Global Change Notification (GCN)

Product Family C'Grid Headers 10673002

Series 74162 February 05, 2015

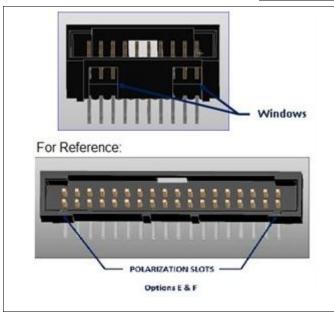
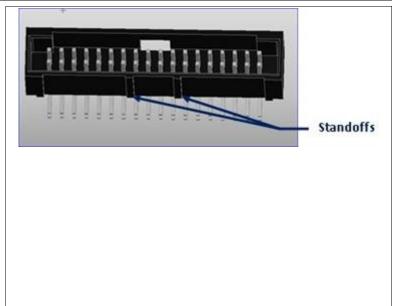
Molex reported in GCN 10651990 that in series 74162, the C and D options were going to be obsoleted and replaced with options E and F. Also reported was that Molex would be removing the bottom two windows on assembly Options A, B, and G. The design change is to improve the robustness of the housings that are used in the 74162 final assembly series. Options E and F do not have windows on the bottom of the housing because of the polarization slots. This notification, GCN 10673002, is to inform you that Molex had decided to reinstate options C and D with the design change to the housings, as well as continue to offer options E and F. The design change to C and D options is to improve robustness of the housings by removing the bottom two windows. Options E and F do not have windows on the bottom of the housing because of the polarization slots. See figure below for change to the housing. A parts list is available upon request.
